PROPOSAL FOR A CORRIGENDA TO REGULATION No. 55,  
DRAFT 01 SERIES OF AMENDMENTS  
(Coupling devices)

Transmitted by the secretariat on behalf of the Expert from ISO

Note. The corrigenda proposed below refers to document TRANS/WP.29/2000/38. The proposal was received by the secretariat from the expert from ISO and it is transmitted for consideration to WP.29 and AC.1.

**Figure 16**

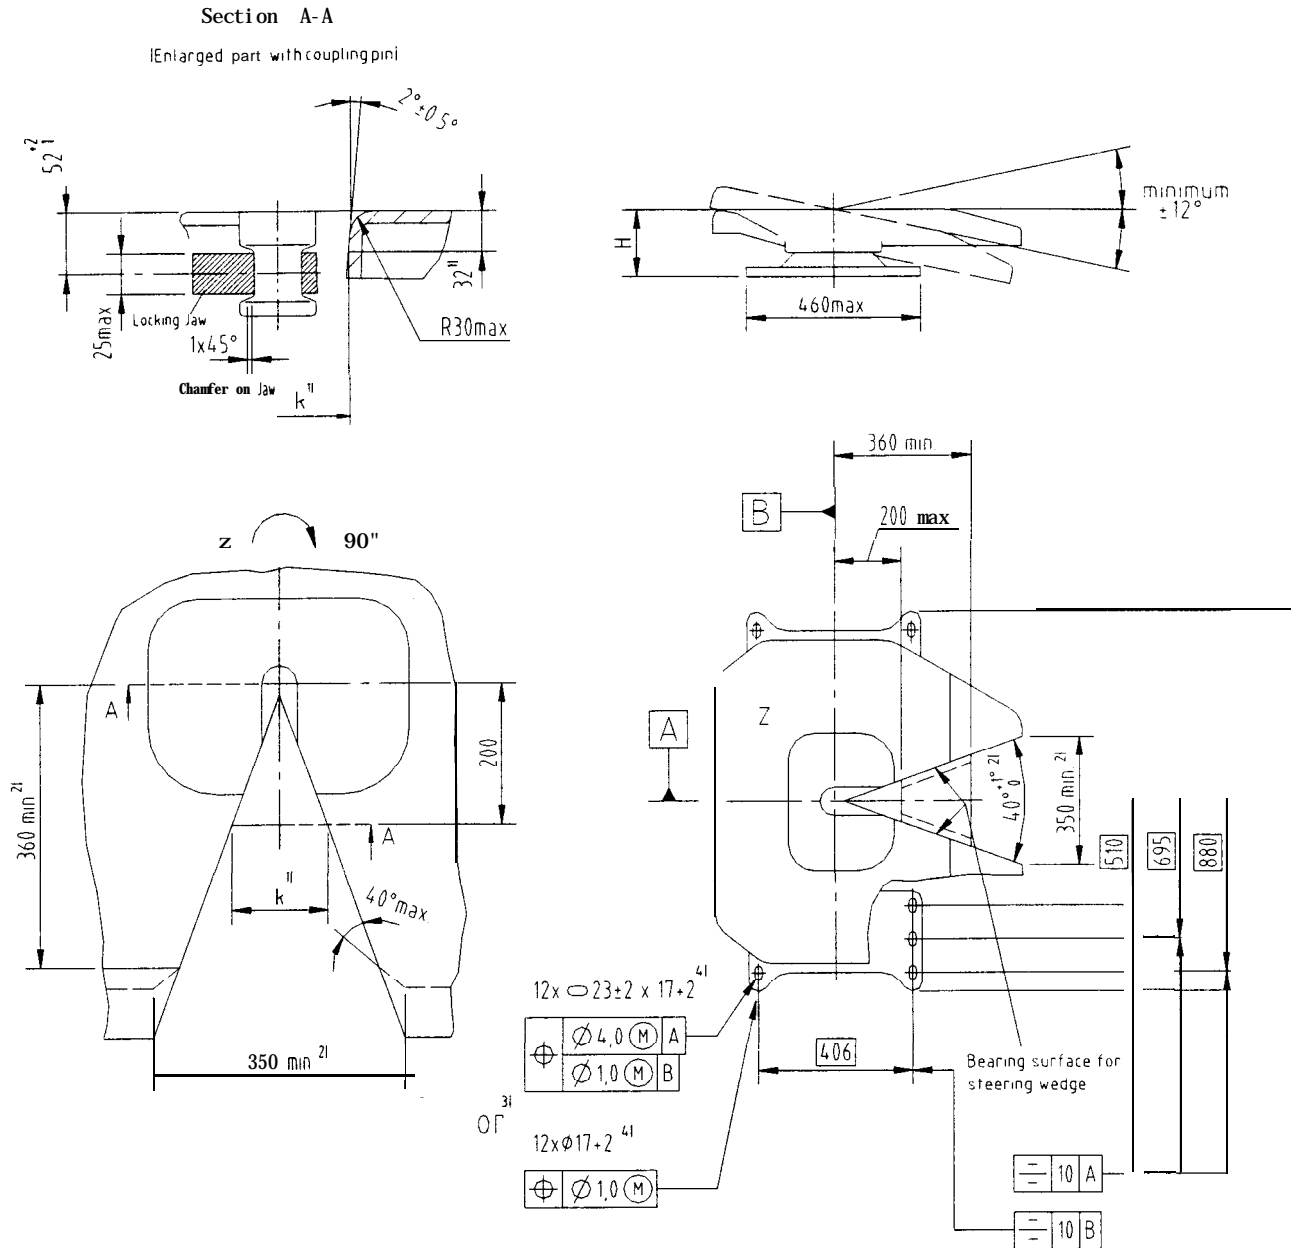
Figure 16, replace by the following (corrected) figure, (introducing also corrected footnote 3/ and a new footnote 4/):

- 3/ Elongated mounting holes 23 ± 2 mm x 17 + 2/-0 mm or round mounting holes Dia. 17 + 2/-0 mm could be used.
- 4/ When using elongated holes or holes > 18 mm diameter, washers 40 mm diameter, 6 mm thick, or means of equal strength, e.g. flat steel plate, are to be used.
